**Re: Defect Information Report – Supplemental Report No. 1
10V-551, FL-584, Missing Tire Inflation Information**

Subject: Certification Door Labels – Tire Inflation

January 2011
FL584 / FL585 / FL586
NHTSA #10V-551

Fig. 1, Location of Correction Label

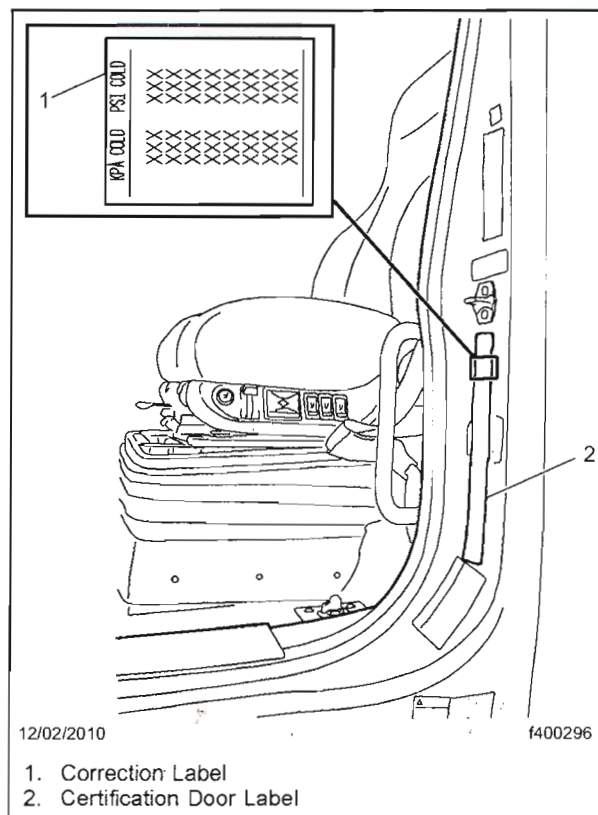
Recommended cold tire inflation pressure information was inadvertently omitted from certain Certification Door Labels. Missing cold tire inflation information may lead to incorrect tire pressures, potentially resulting in premature tire wear and increasing the risk of a crash.

Enclosed you will find a correct overlay label for the Certification Door Label with your involved vehicle identified and the Instructions for attaching the label to the Certification Door Label.

1. Park the vehicle on a level surface. Shut down the engine and set the parking brake.
2. Locate the Certification Door Label on the driver's-side door frame. See **Fig. 1** for location.

NOTE: The new label will cover the section of the Certification Door Label with the headings "KPA Cold" and "PSI Cold."

3. Using a cloth, wipe the indicated area of the label clean. See **Fig. 1**
4. Remove the small label that came in the Recall notice, see **Fig. 2**, from the backing and place it on the Certification Door Label as shown by Item 1 in **Fig. 1**.
